Jitter Nulling

Relevant sections 7.2.3 and 7.5.1

Annex X

Nulling of Intersymbol Jitter

Figure 1: A complete 'cycle' of the K28.5 character

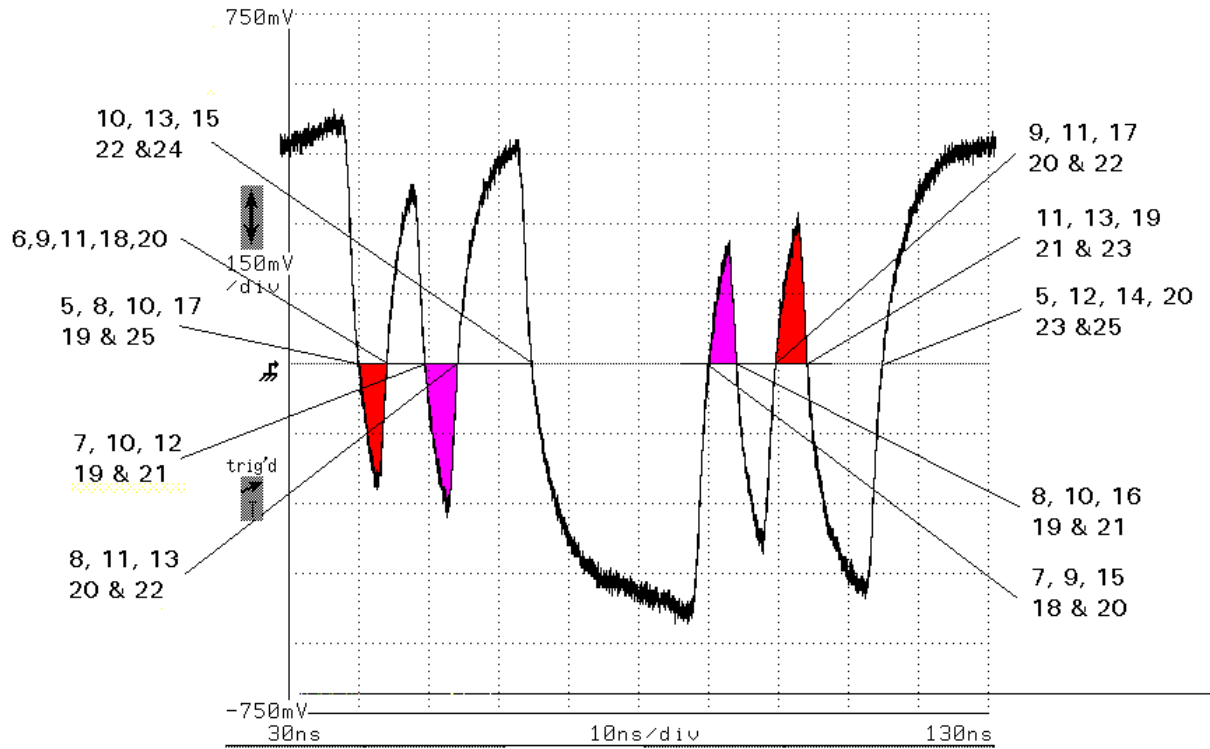
It is not possible for all bit times of a K28.5 DIS character to form part of an 'eye' pattern for mask checking.

The DIS character has only 5 trigger edges in every cycle of 20 bits so for every setting of data bit delay from trigger only 5 data bit times out of the total of 20 will be displayed.

Some combinations of data bit times can never occur.

Figure 1 shows which bit times of the K28.5 DIS character can superimpose for every data bit delay from trigger for delays from 5 to 25 data bit times. The numbers show the data bit delay to every data bit from all possible preceding trigger edges. Only those edges that have a bit delay number in common will superimpose, and then only when the delay is equal to the common number or numbers.

The bit times coloured red will superimpose when the data bit delay from trigger is 17

The bit times coloured purple will superimpose when the data bit delay from trigger is 7

The bit times coloured red cannot superimpose with those coloured purple

This shows that the lowest amplitude +ve bit time and the lowest amplitude -ve bit time cannot be simultaneously checked against the Pulse Masks.
